<b>Title - Sujet</b> Growth Chamber Replacement	
<b>Solicitation No. - N° de l'invitation</b> EZ899-160989/A	<b>Amendment No. - N° modif.</b> 003
<b>Client Reference No. - N° de référence du client</b>	<b>Date</b> 2015-09-24
<b>GETS Reference No. - N° de référence de SEAG</b> PW-\$PWY-028-7611	
<b>File No. - N° de dossier</b> PWY-5-38175 (028)	<b>CCC No./N° CCC - FMS No./N° VME</b>
<b>Solicitation Closes - L'invitation prend fin</b> <b>at - à 02:00 PM</b> <b>on - le 2015-10-01</b>	
<b>F.O.B. - F.A.B.</b> <b>Plant-Usine:</b> <input type="checkbox"/> <b>Destination:</b> <input checked="" type="checkbox"/> <b>Other-Autre:</b> <input type="checkbox"/>	
<b>Address Enquiries to: - Adresser toutes questions à:</b> Lam (PWY), Tian	<b>Buyer Id - Id de l'acheteur</b> pwy028
<b>Telephone No. - N° de téléphone</b> (604) 775-9382 ( )	<b>FAX No. - N° de FAX</b> (604) 775-6633
<b>Destination - of Goods, Services, and Construction:</b> <b>Destination - des biens, services et construction:</b> AAFC - Pacific Agri-Food Research Centre - Summerland, BC

This Amendment 003 is raised to include:

**The following changes/clarifications in the tender documents are effective immediately.  
This addendum w

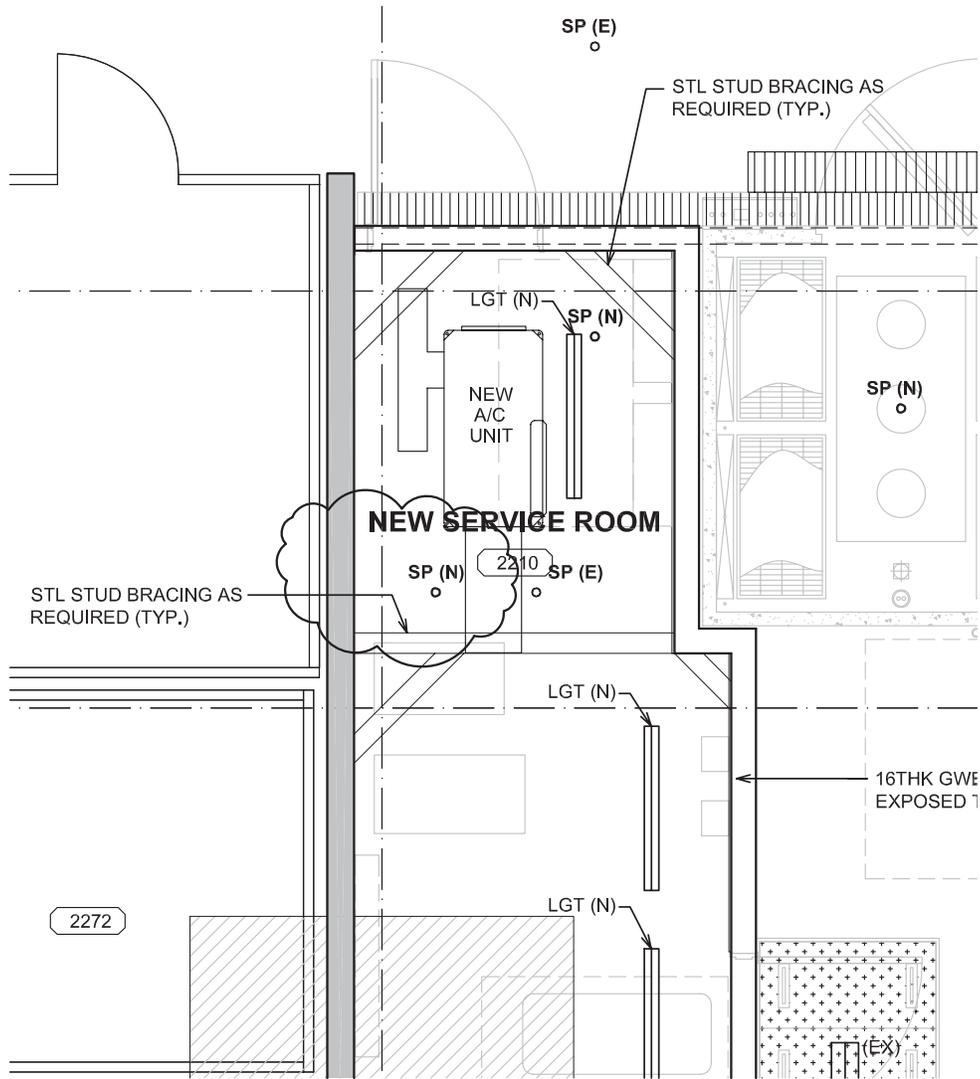
2.1 Refer to attached drawing AD-01 1/05 Reflected Ceiling Plan New Work for minor clarification of sprinkler.

- 
11. Some of the Fire Sprinklers shown on drawing A-05 (GL19) are not included on drawing F-200, are we to include these sprinklers?  
**Response:** Those shown on A-05 are for future chambers. Provide new tees with capped off piping stub for the future sprinkler heads for the Growth Chambers (1 on G.L. 18 and 3 on G.L. 19). Also refer to attached AD-01 for minor clarification.
